CHANGE TO THE APPEARANCE OF DEFLECTING PULLEY 55911

TECHNICAL INFO NO. 1010

Figure 1: 55911 (previous design)

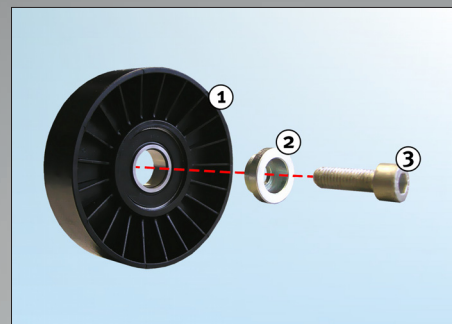
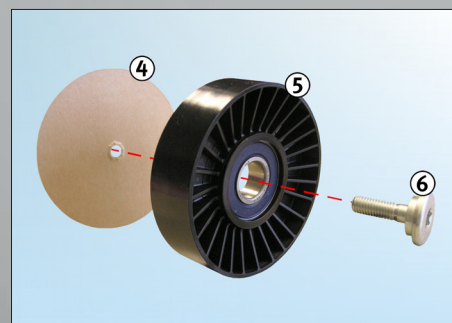
As part of our continuous efforts to improve our products, changes have been made to the deflecting pulley, item no. 55911. This Technical Information shows the visual features of the previous design and the new design.

1. Previous deflecting pulley design
2. Spacer
3. Screw

4. Cardboard disk (screw locking device - must be removed before assembly)
5. New deflecting pulley design
6. Screw (integrated spacer)
